Access Compliance Report

Public Rights-of-Way

(Curb Ramps)

Intersection ID: 43397	Main Street: CENTERLINE_DR	Cross Street: CHAPECLANE_RD	Location: SE
ADA ID: 5197B9A832C8	Ramp Type: PerpDiag	Initial Pass/Fail: Fail	Overall Compliance: No
Severity Score: 10			
Codes/Mitigation Info/Possible Solution		Field Measurements/Component Compliance

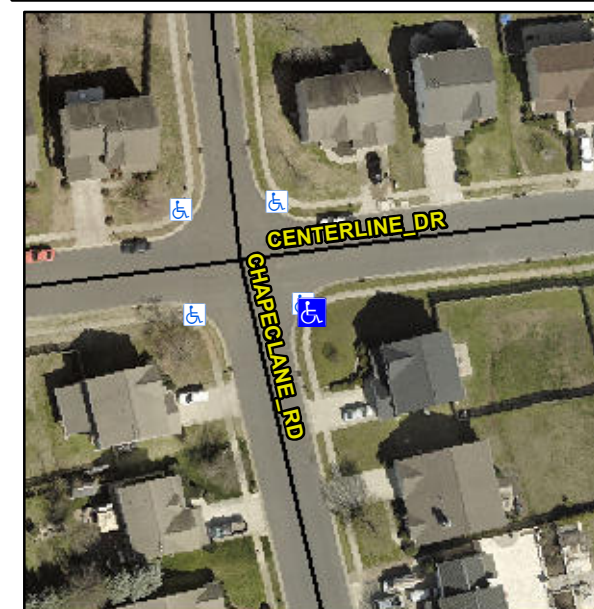
Not Found, R304.5.1, R304.5.3

Compliance	Description	Data	Compliance	Description	Data
N/A	Ramp Length (in)	47.0	Yes	Ramp Slope (%)	7.7
No	Ramp Width (in)	39.0	No	Ramp XSlope (%)	3.9
N/A	Flare Type LT	N/A	N/A	Flare Type RT	N/A
N/A	Flare Slope LT (%)	N/A	N/A	Flare Slope RT (%)	N/A
N/A	Flare Traversable LT?	N/A	N/A	Flare Traversable RT?	N/A
N/A	Landing Length (in)	N/A	N/A	DWS Provided?	N/A
N/A	Landing Width (in)	N/A	N/A	DWS Contrast?	N/A
N/A	Landing Slope (%)	N/A	N/A	DWS Length (in)	N/A
N/A	Landing X Slope (%)	N/A	N/A	DWS Full Width?	N/A
N/A	Landing Curb? (Y/N)	N/A	N/A	DWS Offset (in)	N/A
N/A	Shared Landing?	N/A			
N/A	Gutter Ponding?	N/A	N/A	Gutter Slope (%)	N/A
N/A	Gutter Lip Ht (in)	N/A	N/A	Gutter X Slope (%)	N/A
N/A	Painted X Walk1?	No	N/A	Painted X Walk2?	No
	X Walk 1 Direction	To N		X Walk 2 Direction	To W
N/A	X Walk 1 Width (in)	N/A	N/A	X Walk 2 Width (in)	N/A
	X Walk 1 Slope (%)	0.0		X Walk 2 Slope (%)	1.6
	X Walk 1 X Slope (%)	3.4		X Walk 2 X Slope (%)	0.7

N/A	Ramp inside XWalk1?	N/A	N/A	Ramp inside XWalk2?	N/A
	Road Slope (%)	2.1	N/A	Clear Space?	N/A
	Road X Slope (%)	0.2	N/A	Clear Space to XWalk (in)	N/A
N/A	Any Obstructions?	N/A	N/A	Storm Grate/Utility Hazard?	N/A
	Obstruction Type			Storm Grate/Utility Type	
		N/A			N/A
		Yes		Surface Condition? (G/P)	Good

Remove & Replace Curb Ramp With Two New Directional Ramps or Equivalent.
